Architect's Supplemental Instructions

Architect's ASI No: 022

Project:
Webster University
Interdisciplinary Science
Building

Description: ASI – 022 (RFI-234)

1 LEVEL 01 AREA B FLOOR PLAN - PLUMBING
1/8" = 1'-0"

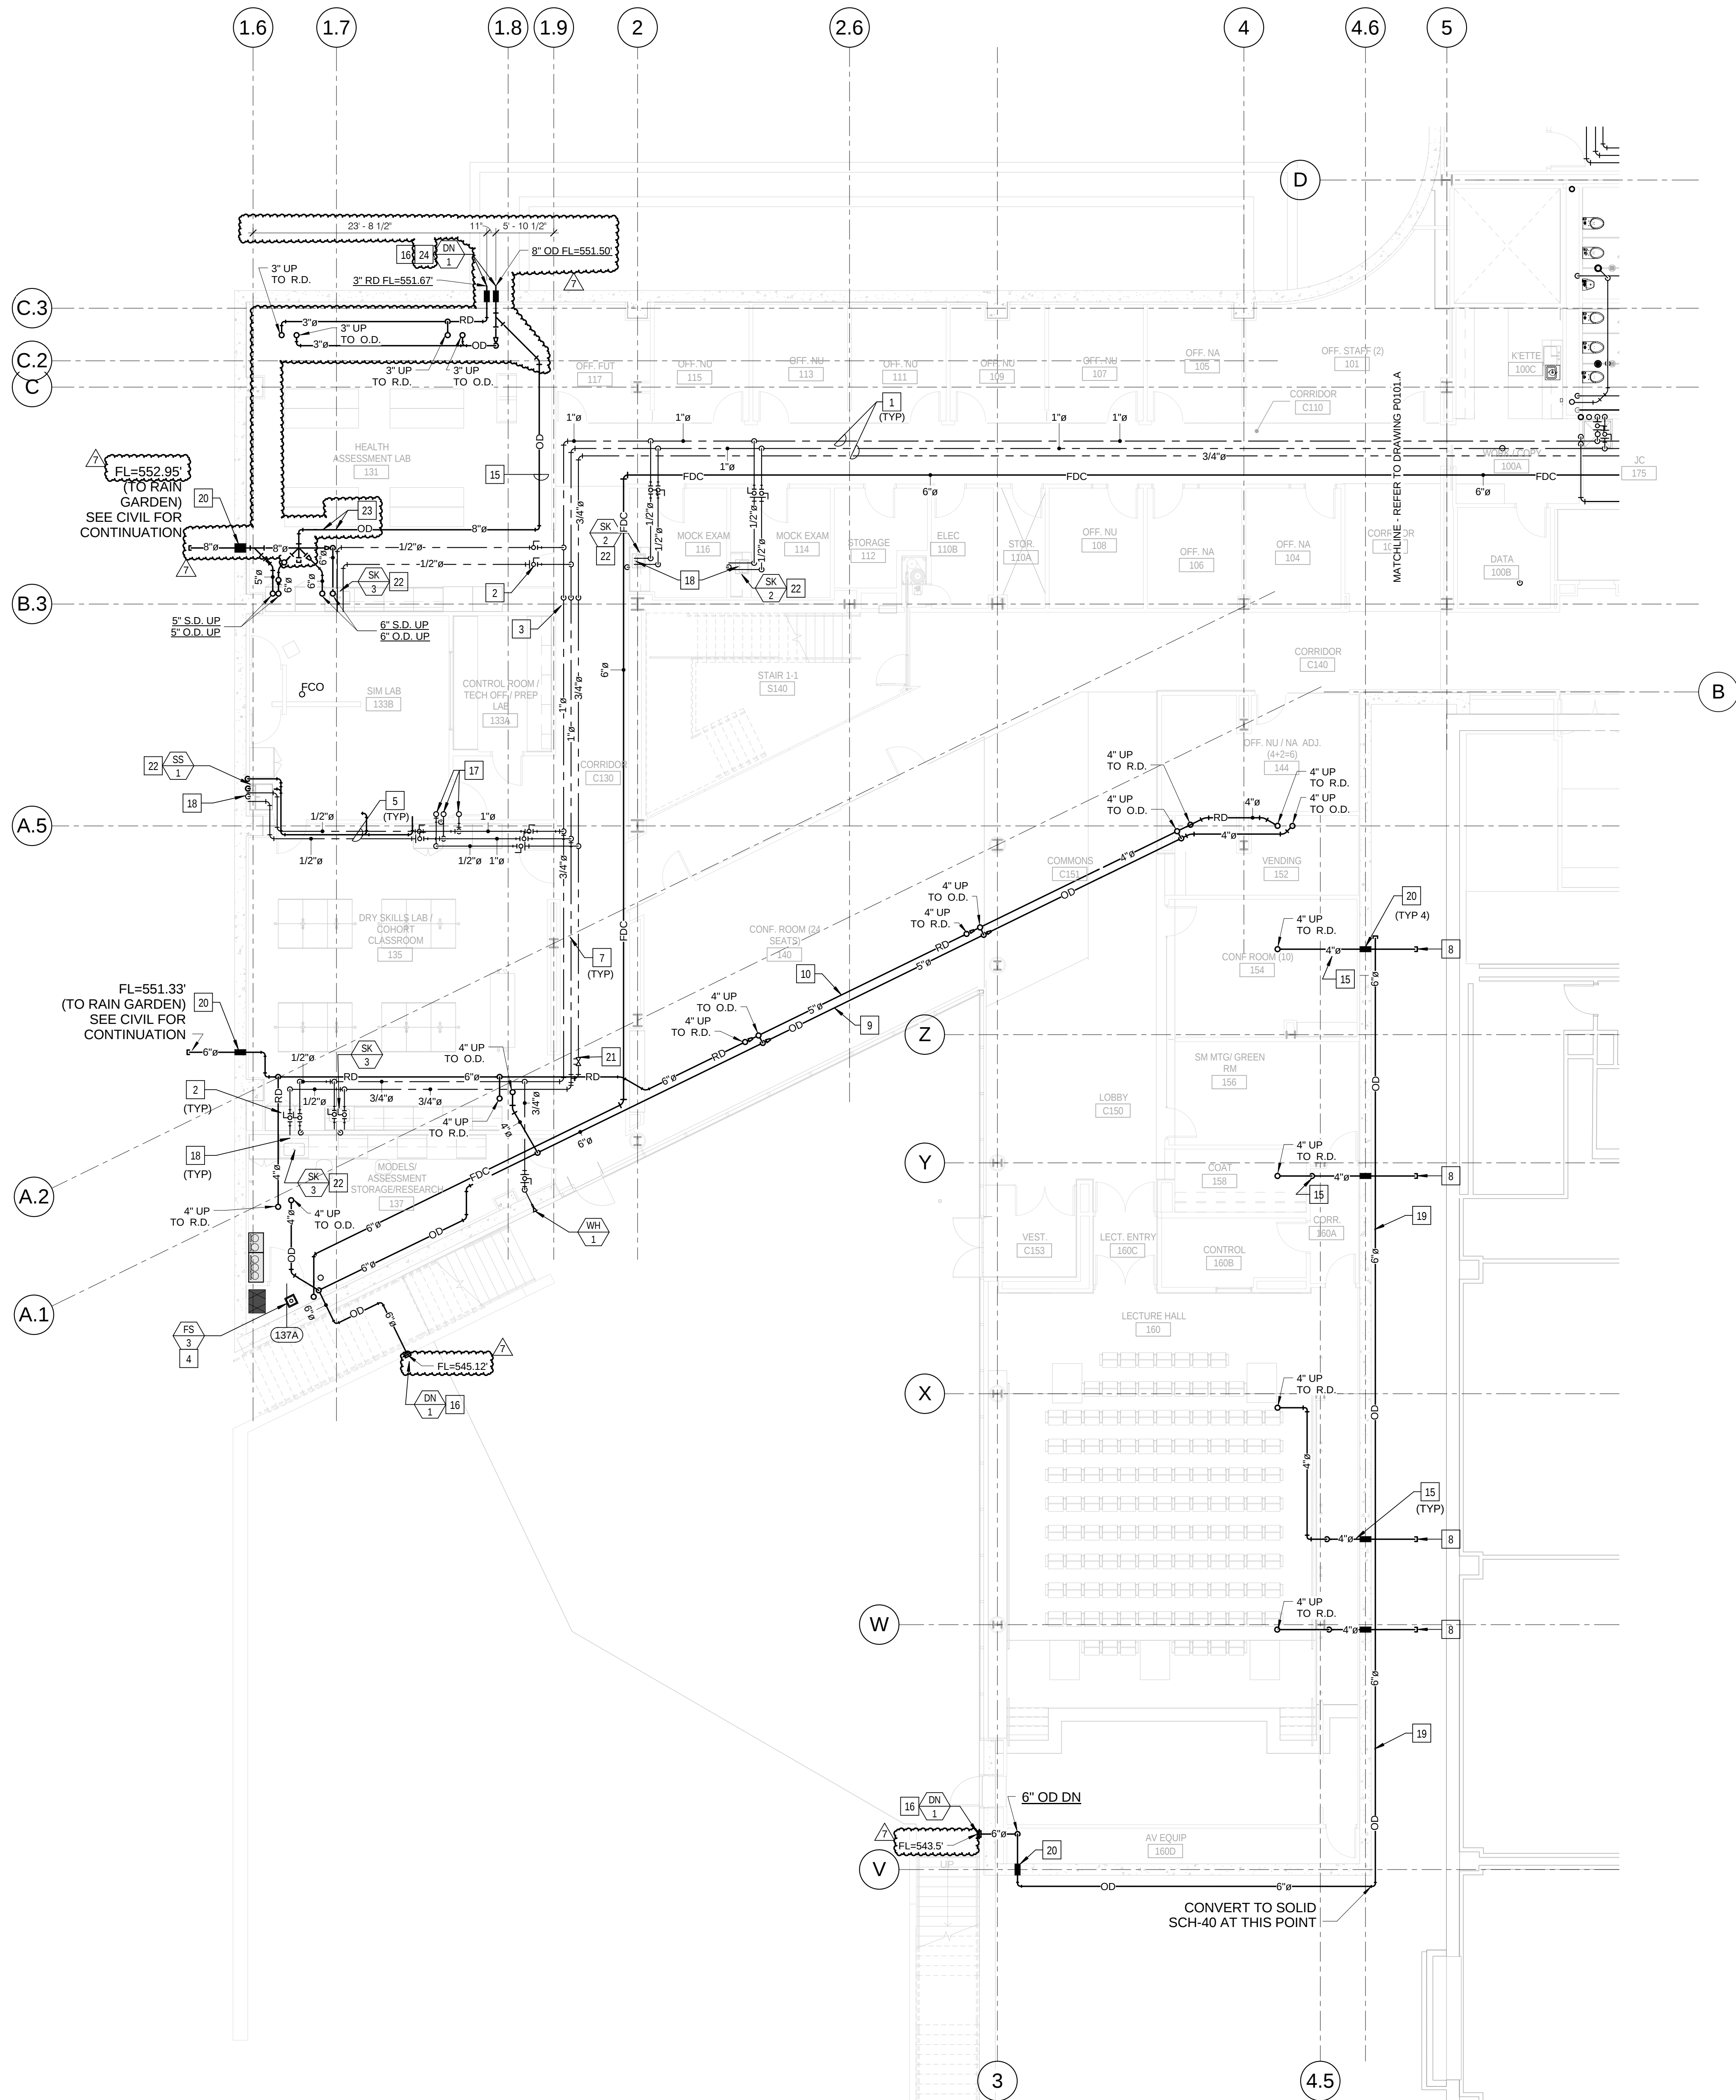
RFI-234, (P0101.B); Per RFI-234, there was conflict with a 3-inch storm drain line at column C. To correct this issue the following have been incorporated. The storm drain and overflow drain piping serving the 2-additional area drains have been reconfigured to avoid conflict with the bottom of the I-beam. First we re-routed the piping for the 2 new area drains to the north, which will requires a new wall core, sleeve and downspout nozzle cover. This allows us to remove the 3-inch storm drain line from the propose system along the east wall, and reduce the pipe size from 10-inch line to an 8-inch line into the rain garden. Also, we adjusted flow line of the 8-inch storm drain discharge. Some minor changes were made to the 8-inch overflow line crossing the 8-inch storm line. Refer to drawing P0101.B for new keyed note, number 23 addressing this issue and all of the above changes as well.

- 22 REFER TO DRAWING P0402, DETAIL 3 FOR RISER DIAGRAM.
- 23 HOLD 8" STORM OVERFLOW PIPING AS HIGH AS POSSIBLE TO BOTTOM OF STEEL MEMBERS TO AVOID CONFLICT. OFF-SET BELOW BEAM AT COLUMN LINE 1.7. MAINTAIN A MINIMUM OF 2 PERCENT SLOPE TO DOWN SPOUT NOZZLE AT NORTH SIDE OF BUILDING.

A0312

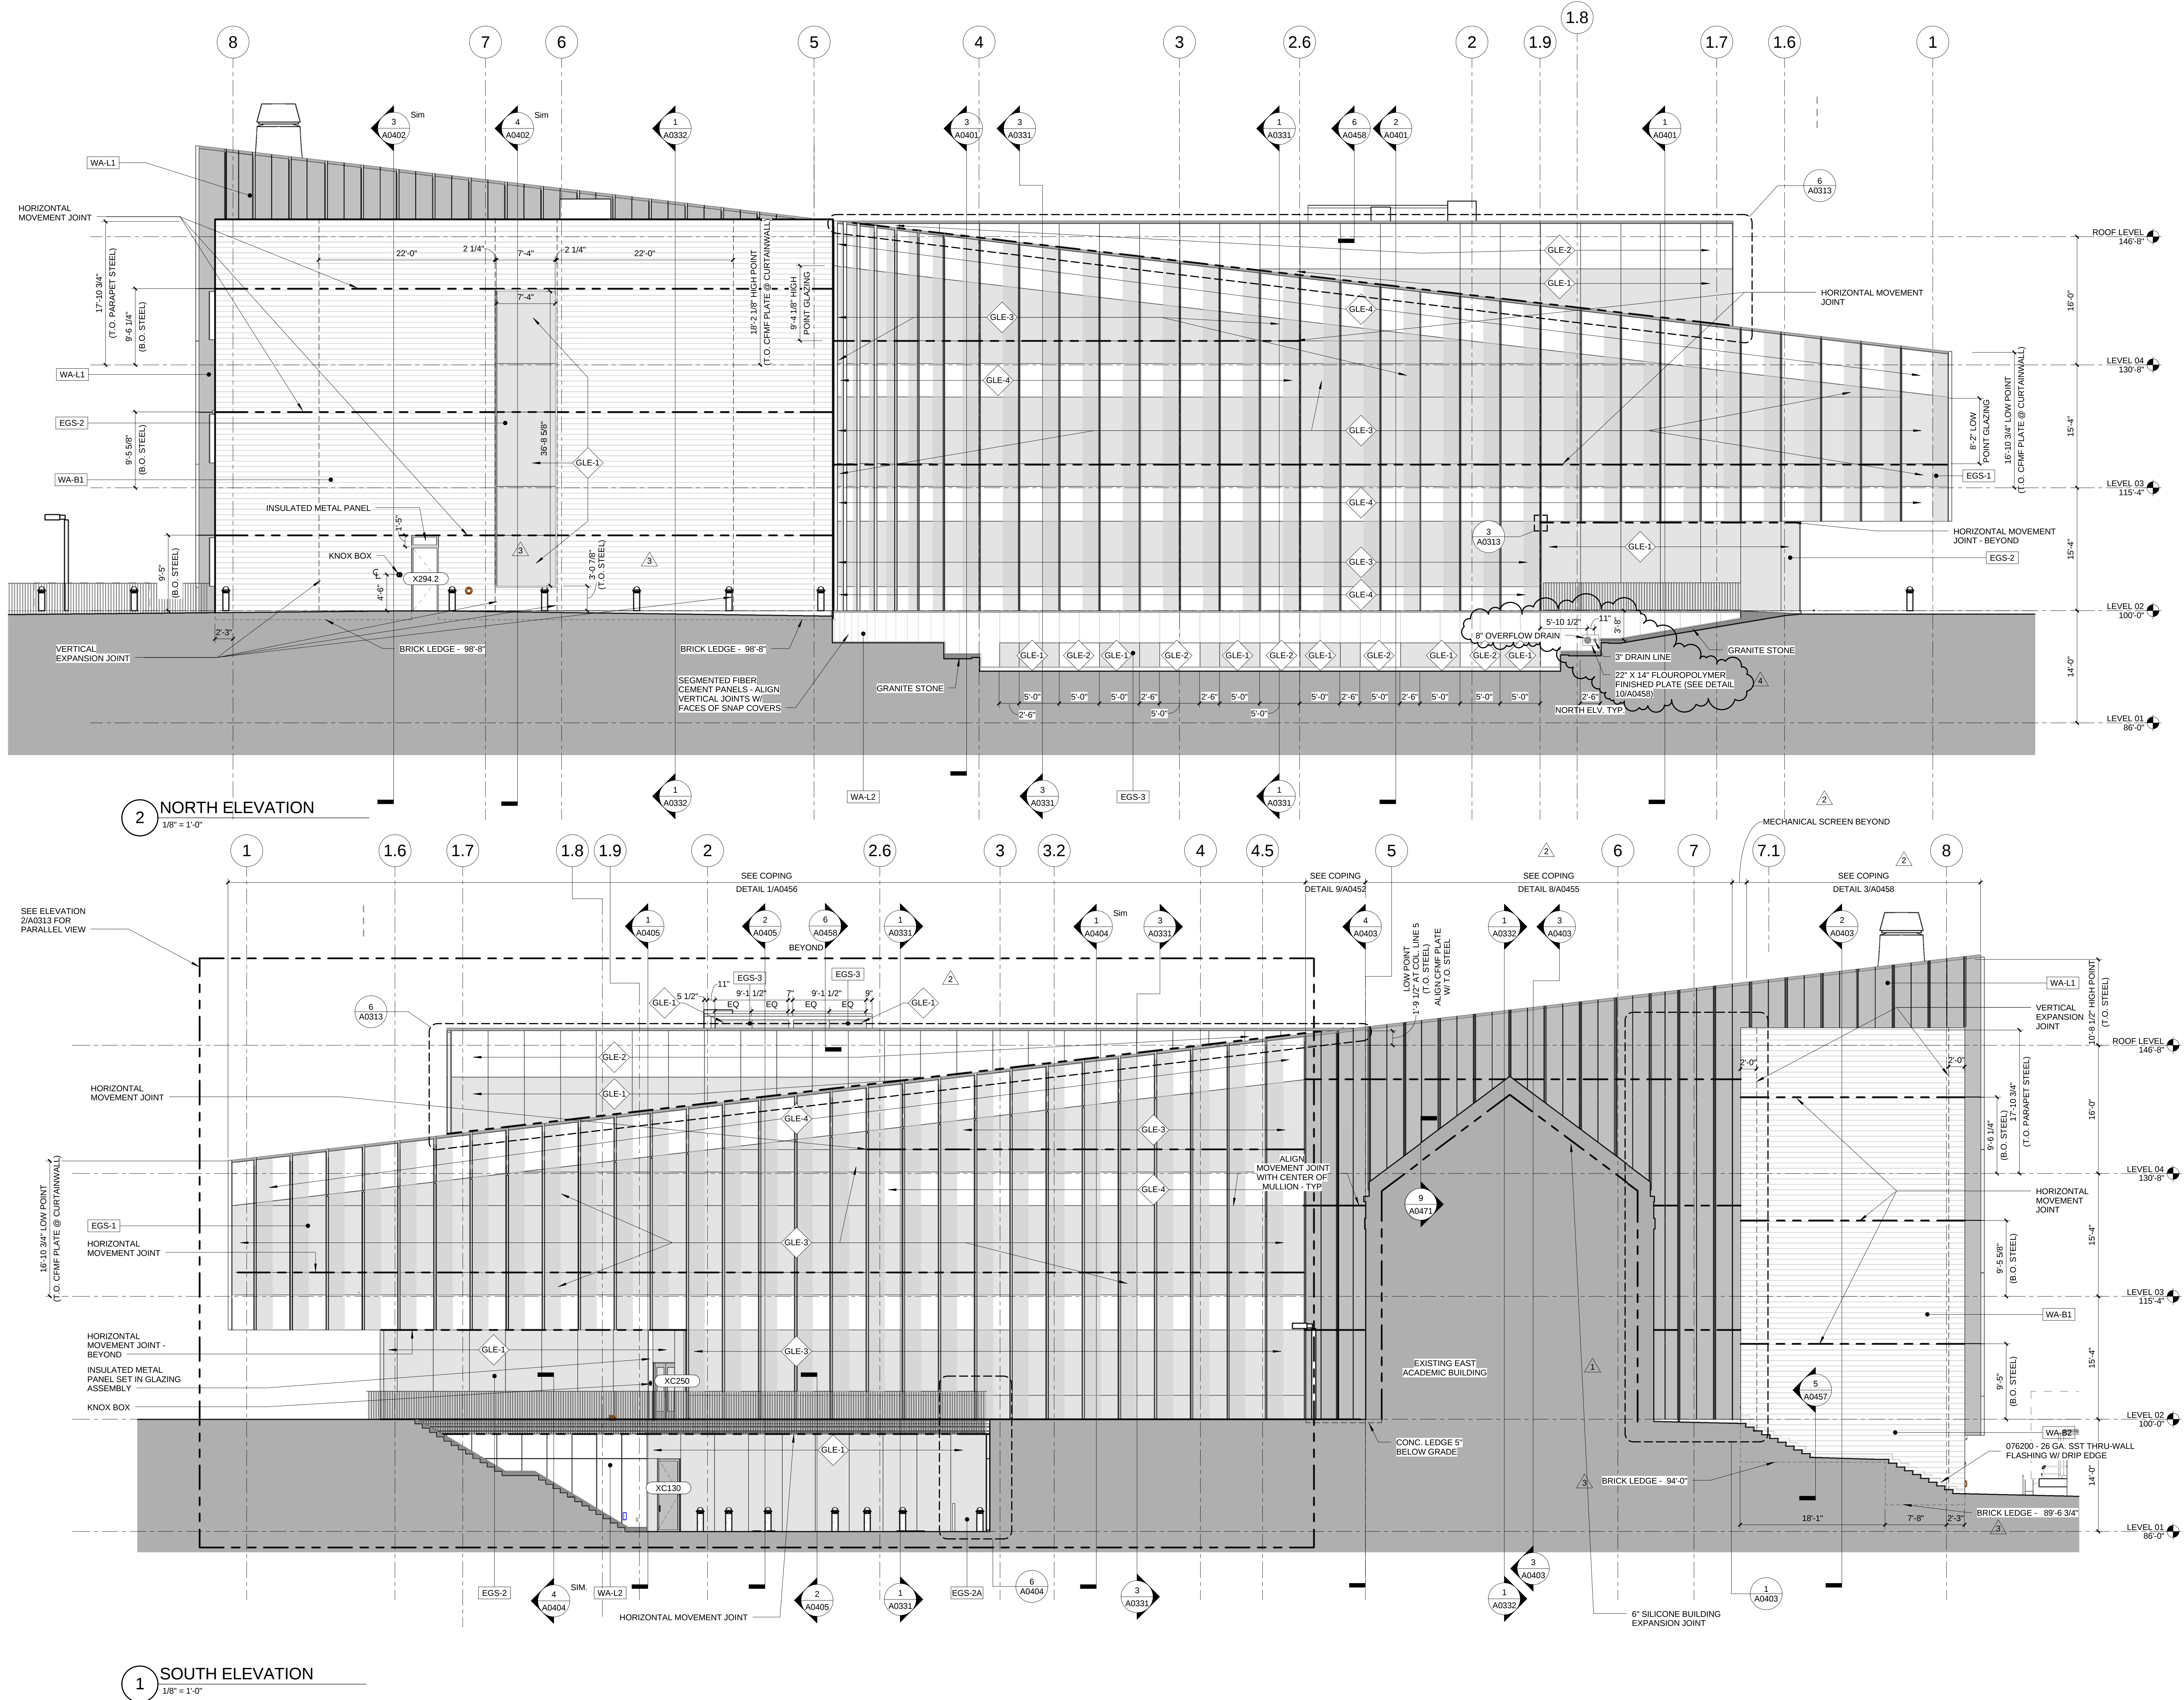
Revised north elevation on sheet A0312 to show new drain nozzles. Added detail 10 enlarged elevation and detail 9 section at drain nozzles to sheet A0458.
